## Board of Zoning Appeals

**SBVA-1125-000004 11446 Alpharetta Highway**

**Subject:** SBVA-1125-000004, 11446 Alpharetta Hwy

Re: Genesis Renovation, 150' Stream Buffer Variance.

### STORMWATER NARRATIVE

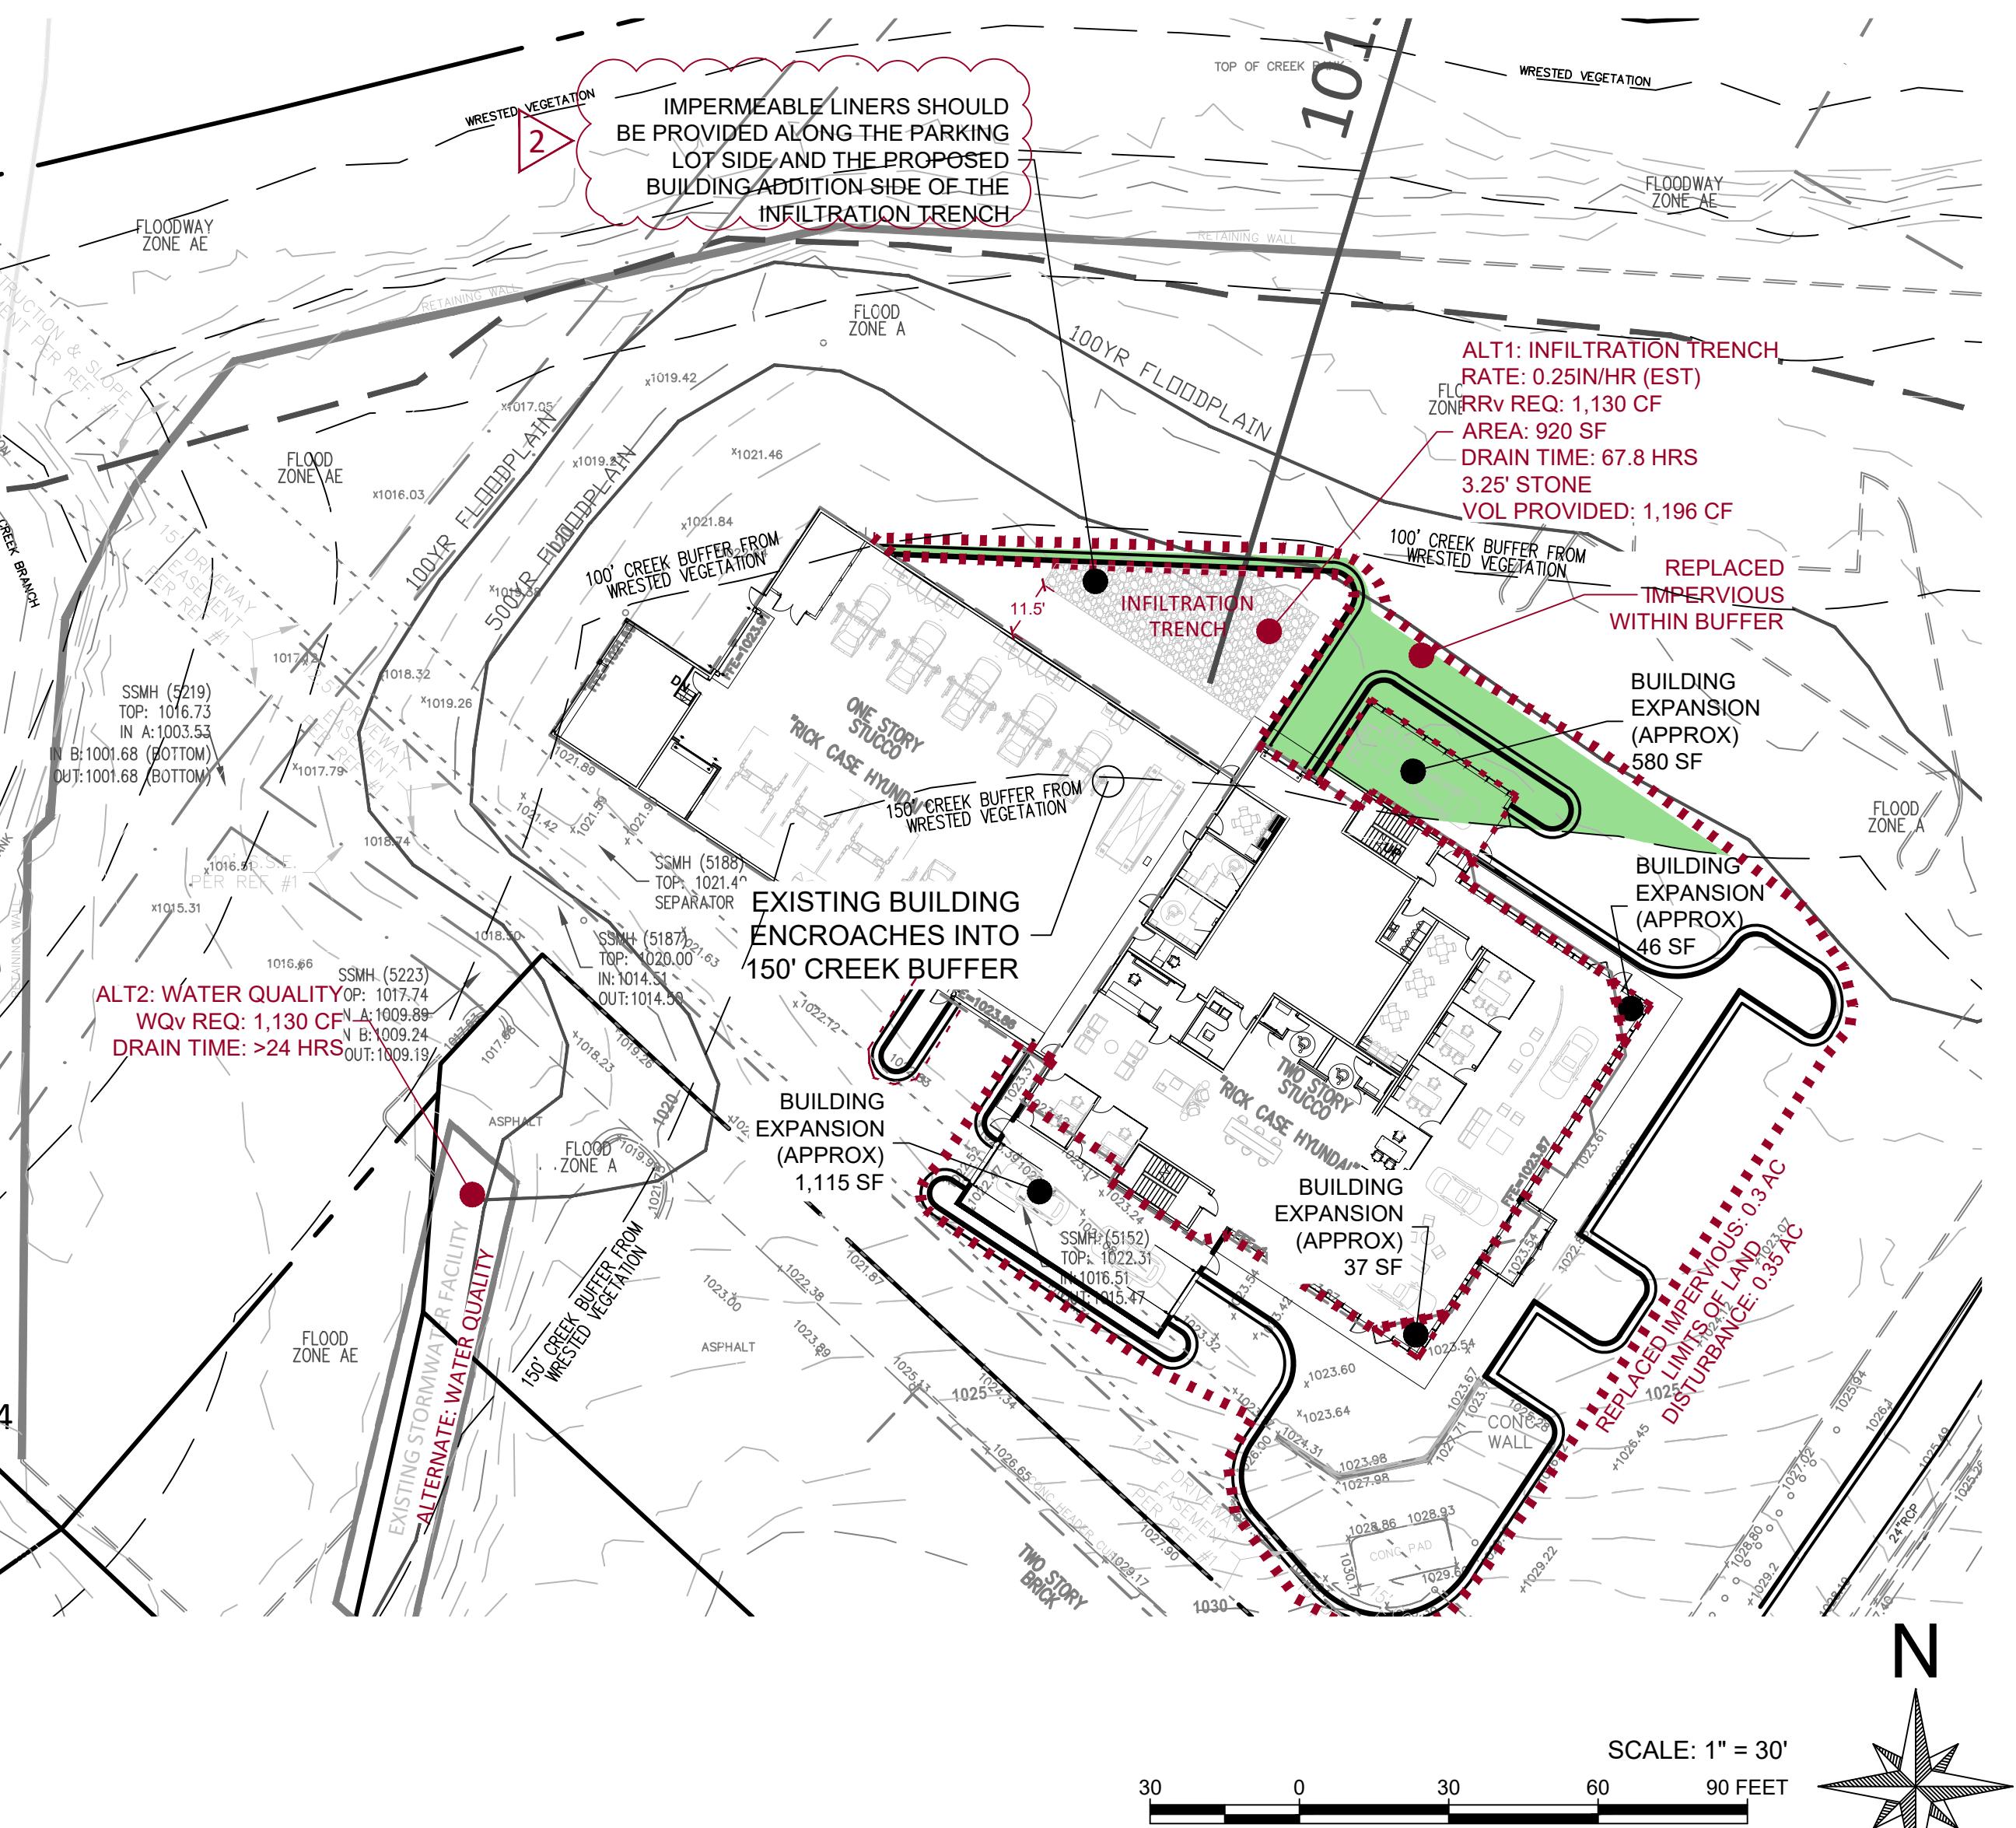
Comments	Coleman Cleveland ccleveland@roswellgov.com			
Corrections	General (Not Resolved) - Please provide callout for impermeable liners on the parking lot and building addition sides of the proposed infiltration trench.			
<b>eREVIEW SESSION FILES:</b> 25413 WQ 01-07-26_v1.pdf				
REVIEWER	MARKUP	DATE/TIME	FILE NAME	PG #
Osmany	Replace WQ spreadsheet with a table indicating total new or replaced impervious/pervious in square feet and also new or replaced impervious/pervious (square feet) of buffer intrusion. The total new or replaced gets treated for RRv as required per code and the intrusion area gets treated for 1.5 times or 50% extra. For example if it's 1000 SF x 1.5 times = 1,500 SF. Having the entire WQ spreadsheet may create some confusion for the board. These are not engineers. You want to make it very simple to show how much RRv is required and how much RRv extra is provided as mitigation.	01/14/2026 7:33	PM25413 WQ 01-07-26_v1.pdf

Osmany	Also, provide a x-sectional detail of the proposed infiltration trench.	01/14/2026 7:50	PM25413 WQ 01-07-26_v1.pdf

STORMWATER TREATMENT IS PROVIDED BY A PROPOSED INFILTRATION TRENCH LOCATED IN THE NEW PERVIOUS AREA ADJACENT TO AND NORTH OF THE BUILDING.

THE TRENCH IS SIZED USING A CONSERVATIVE INFILTRATION RATE OF 0.25 IN/HR. IF INFILTRATION TESTING DOES NOT SUPPORT THIS RATE, THE REQUIRED WQV WILL BE TREATED IN THE EXISTING STORMWATER POND, AS SHOWN ON THE PLANS.

Infiltration Trench Design Calculations		
RRv-Req	1135	cf Runoff Reduction Vol. Req'
i	0.25	in/hr Infiltration Rate
t	72	hr Max Recovery time
h	18	in Depth recover in 72-hr
A-Min	756.6667	sf Infiltration Area Required
A-Prov	920	sf Infiltration Area Provided
t-Prov	59.22	Actual Recovery Time
D-stone	3.25	ft Depth of Stone
RRv-Prov	1196	sf Runoff Reduction Volume Provided
